**Plumbing Board
Request for Interpretation**

RFI File No. PB0229	Date Received by DLI 3/24/2026	Dated Received by Board 4/21/2026	Date of Board Meeting 4/21/2026
Title of RFI PB0229.RFI.David Weum.Storage Overflows	By:

MDH considers overflows from these structures to be solely MDH's jurisdiction and not part of the plumbing system as there are no plumbing fixtures, devices, appurtenances, or appliances involved in these installations. These storage structures are part of the public drinking water system rather than the property specific plumbing system, and the overflows are an integral part of the structures.

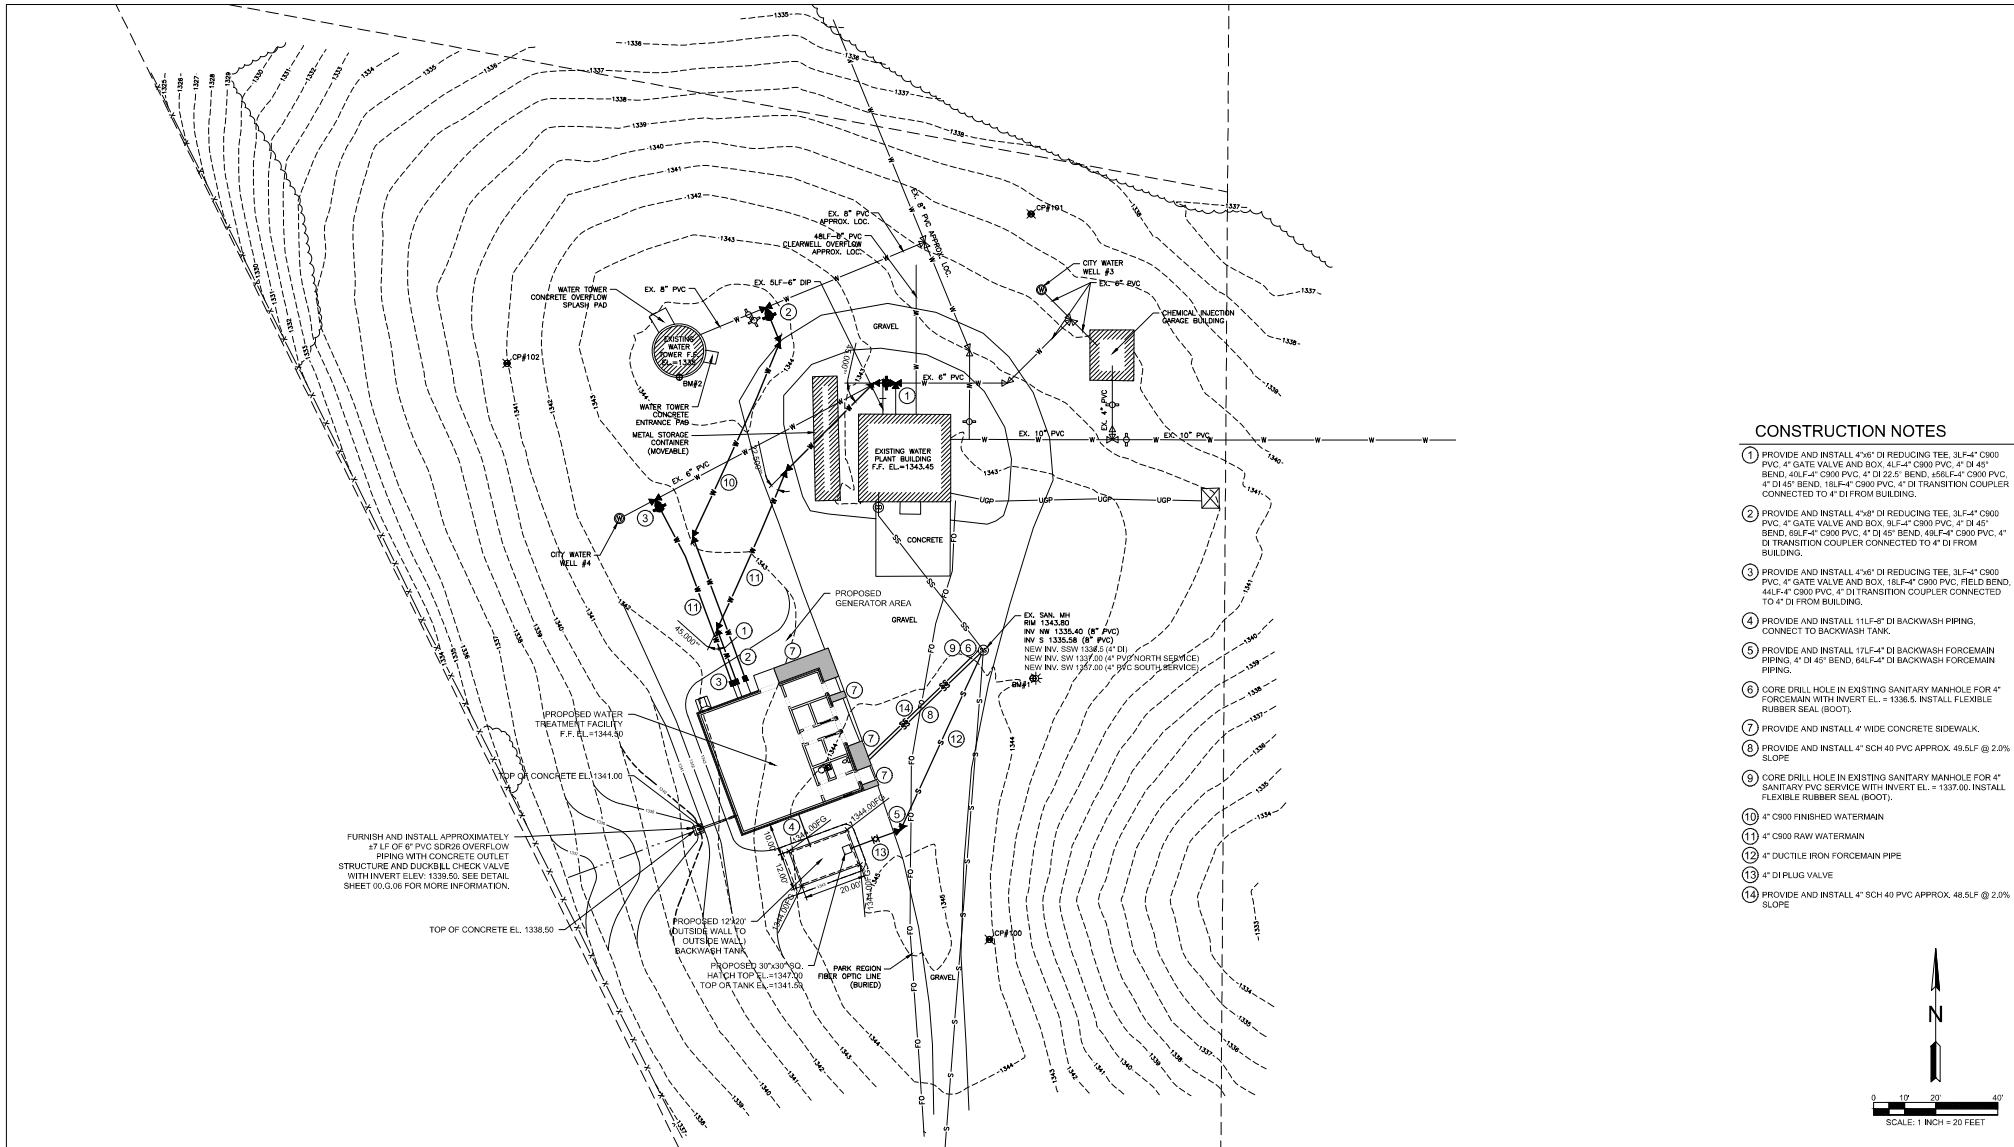
Everyone can agree that storage overflow pipes need to have a means to protect the water in storage from contamination. Usually this is done with a screen. However, that screen would create an obstruction of flow and conflict with 310.5 if we consider this pipe drainage. DLI has said that this obstruction is acceptable since screens are required on overflows in Chapter 6.

In order to include chapter 6 as applicable here, you'd need to interpret municipal storage to fall under "water supply system" in 601.1. However, MDH does not see municipal storage as meeting any part of the definition of water supply system in the plumbing code. The definition is meant to be restricted to a plumbing water system and not to encompass drinking water production at a municipal level.

LOWER LEVEL PLAN

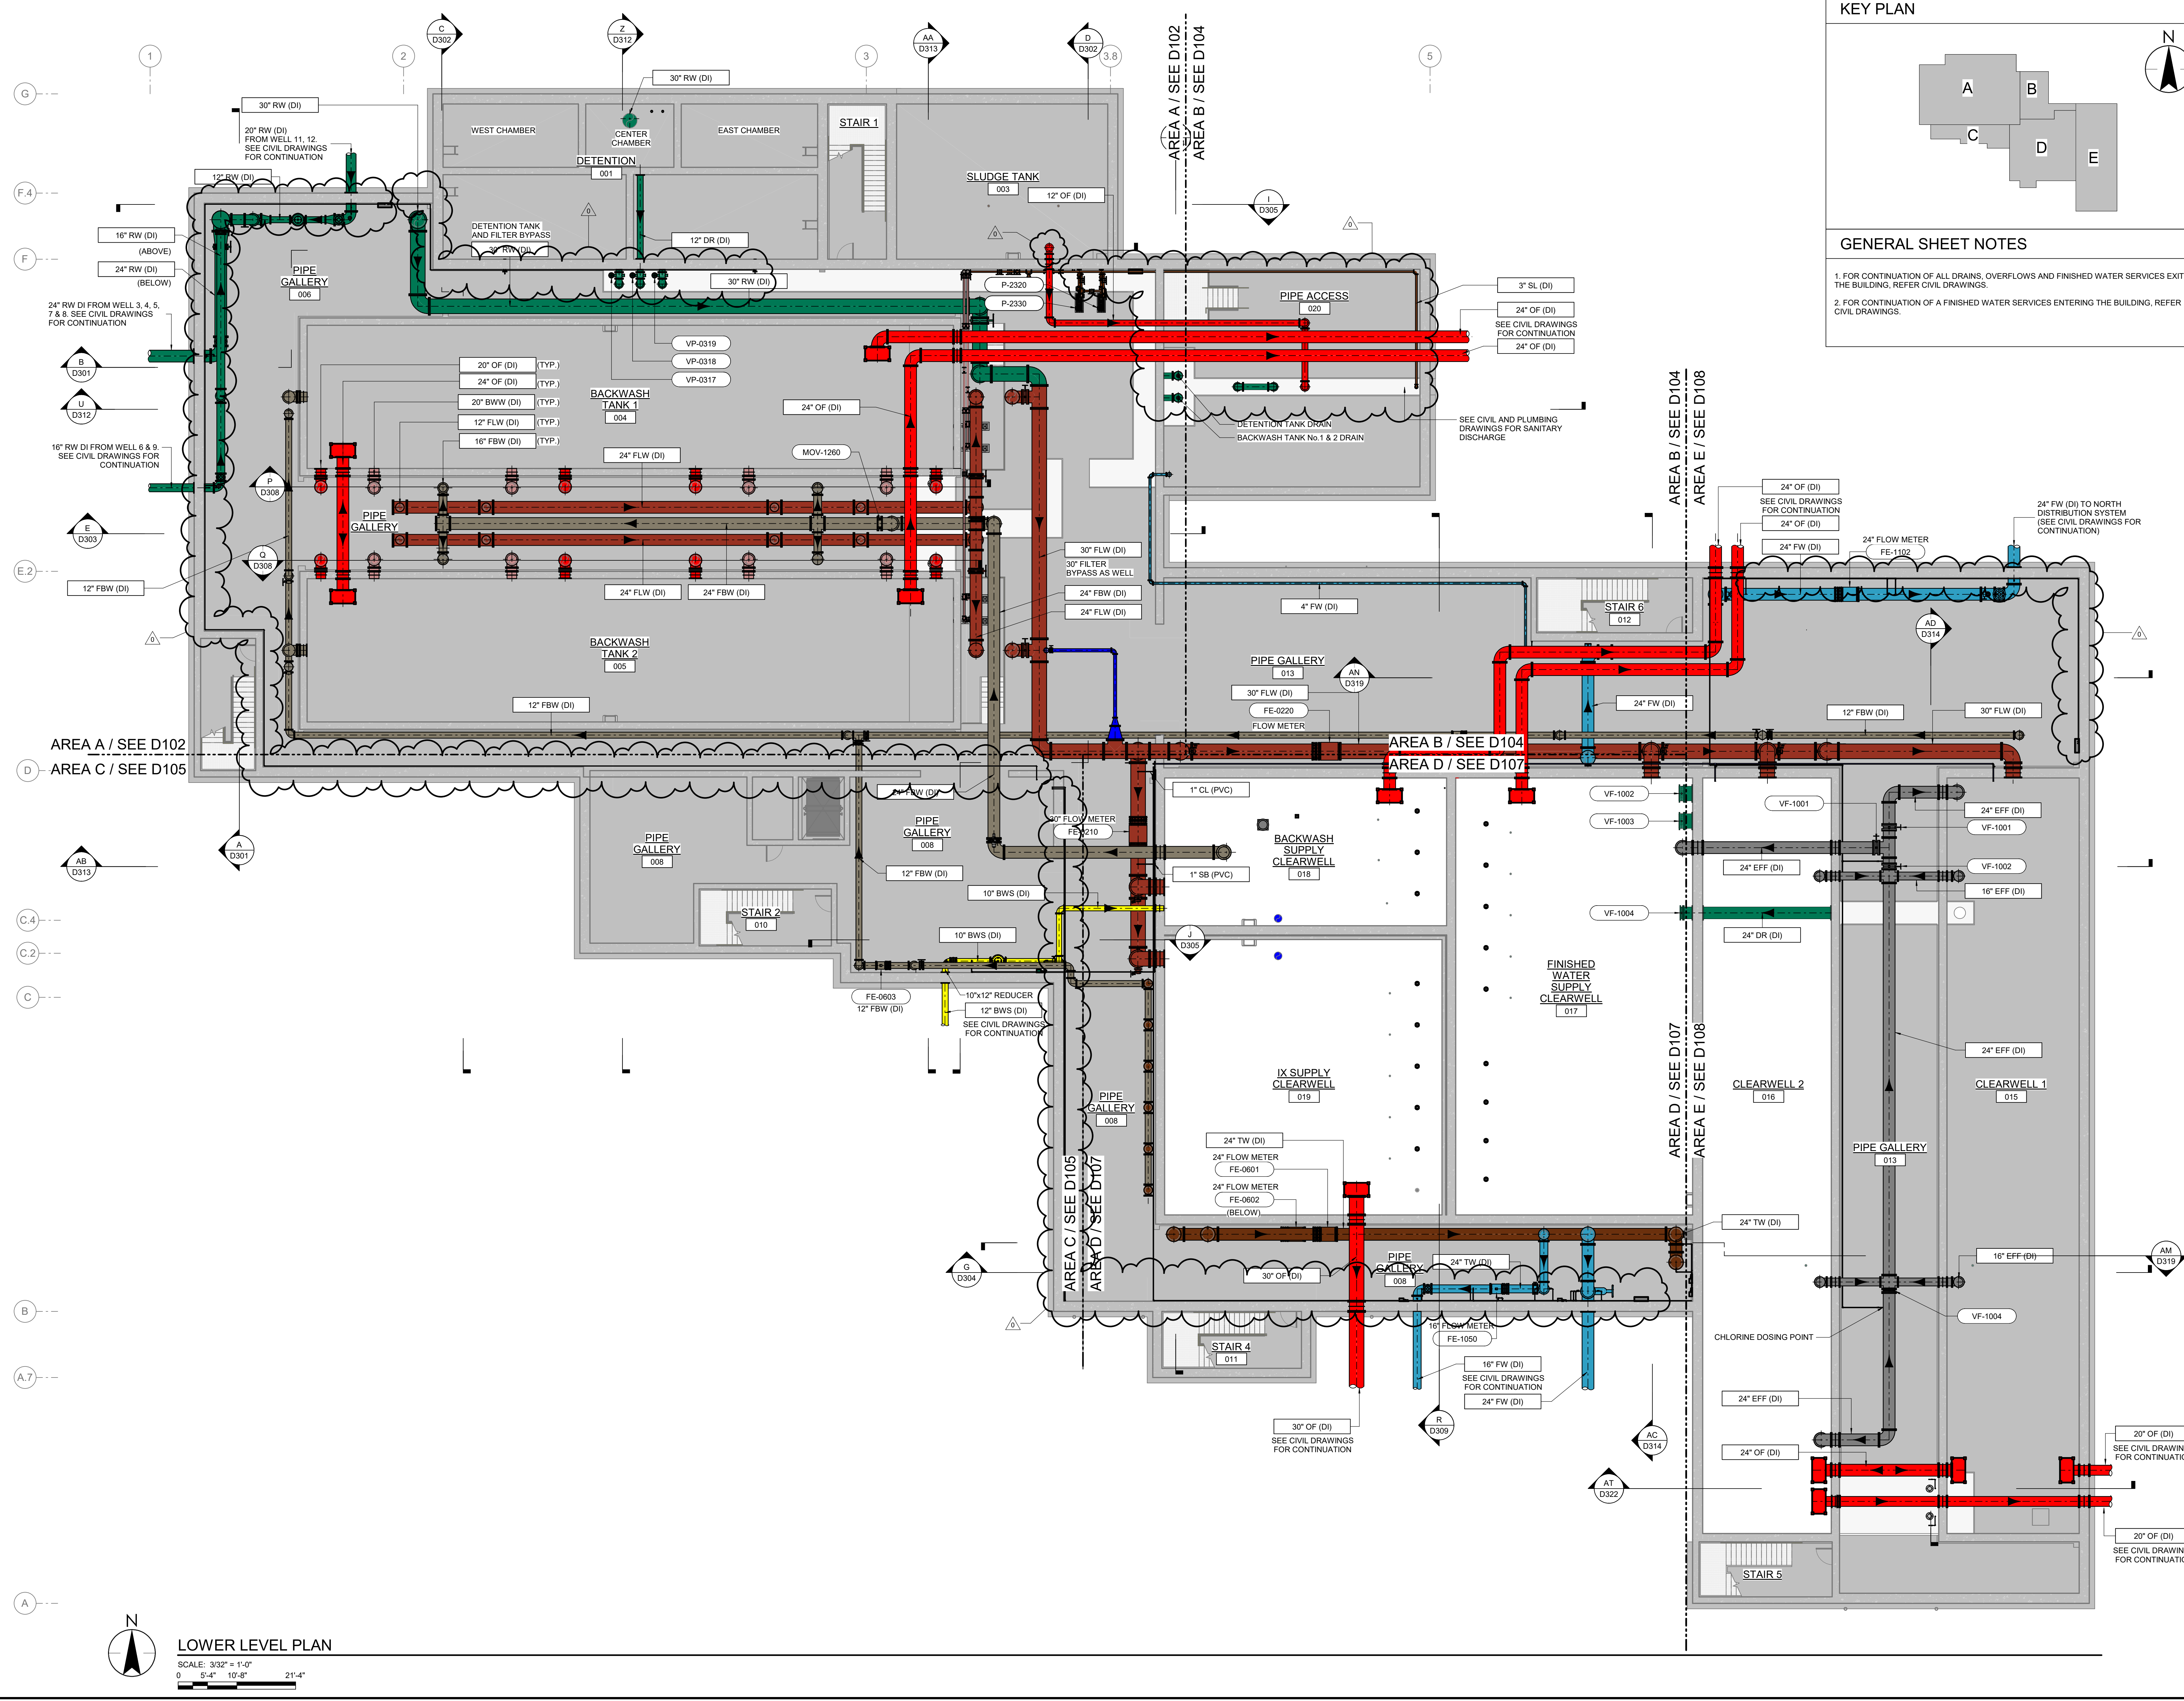
If the plumbing code was fully enforced on this infrastructure, this would create mass noncompliance and I don't think it actually can be fully complied with between trapping and venting (803.3), discharging to the building sewer(801.2), obstruction of flow(310.5), screening(607.4), being both a indirect waste pipe and drainage system(chapter 2), and the various applicability sections (801.1, 601.1). In the more extreme/silly scenario, this would seem to require a plumber to install the overflow pipe on every water tower constructed in Minnesota.

In MDH's opinion, this all speaks clearly to the plumbing code not being appropriate to apply to drinking water storage overflows, and that these overflows are part of an engineered storage design for treating and distributing water to an entire city drinking water system. The municipal water system is separate from plumbing since it serves multiple properties and while it does need to be located on a property, that does not make it suddenly plumbing.
